INCH-POUND
MIL-H-83511/2
AMENDMENT 1
15 October 1999

MILITARY SPECIFICATION SHEET

HEADSET-MICROPHONE
H-157A/AIC

This amendment forms part of Military Specification Sheet MIL-H-83511/2, dated 04 April 1978, and is approved by all Departments and Agencies of the Department of Defense.

Alternate locking thumbnut configuration.

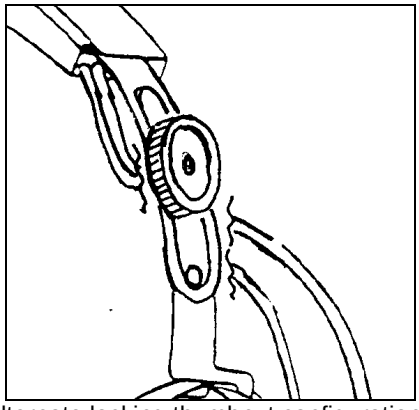
FIGURE 1: Add to Figure 1 Alternate configuration to the sliding action is a positive locking thumbnut.

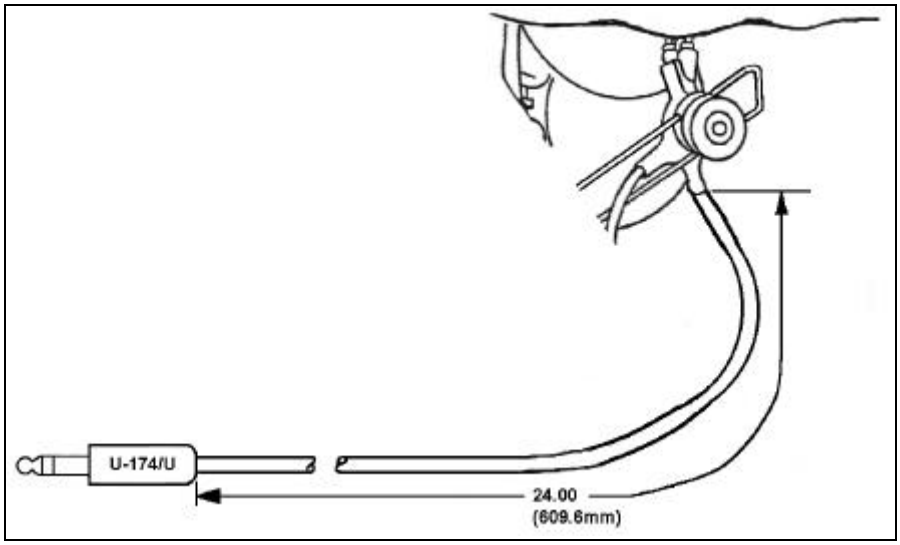
FIGURE 1: Delete the adapter cable and substitute to the main cable assembly as shown:

FIGURE 2. Wiring diagram for H-157A/AIC

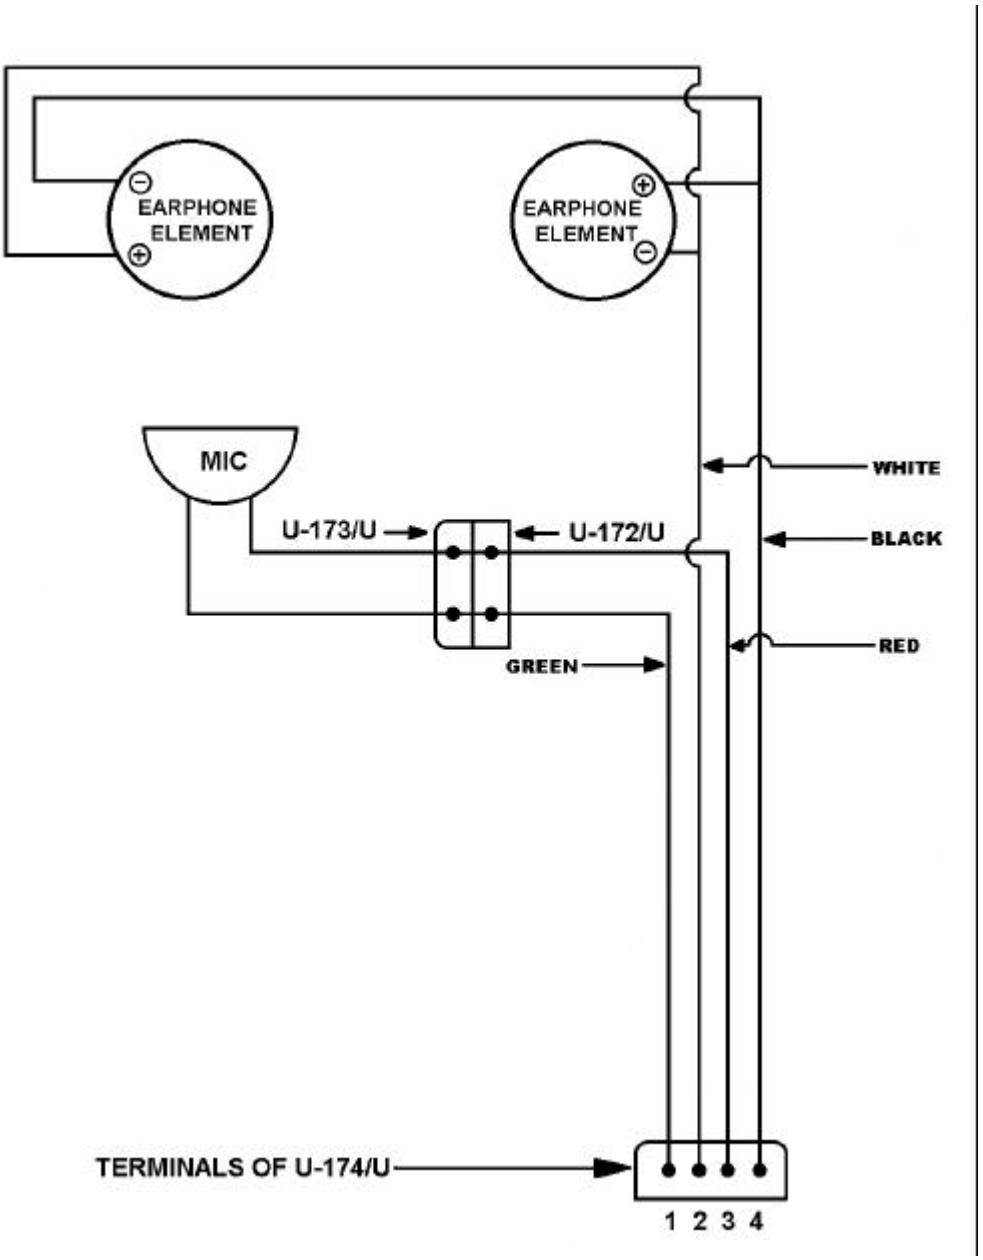
FIGURE 2: Delete and substitute:
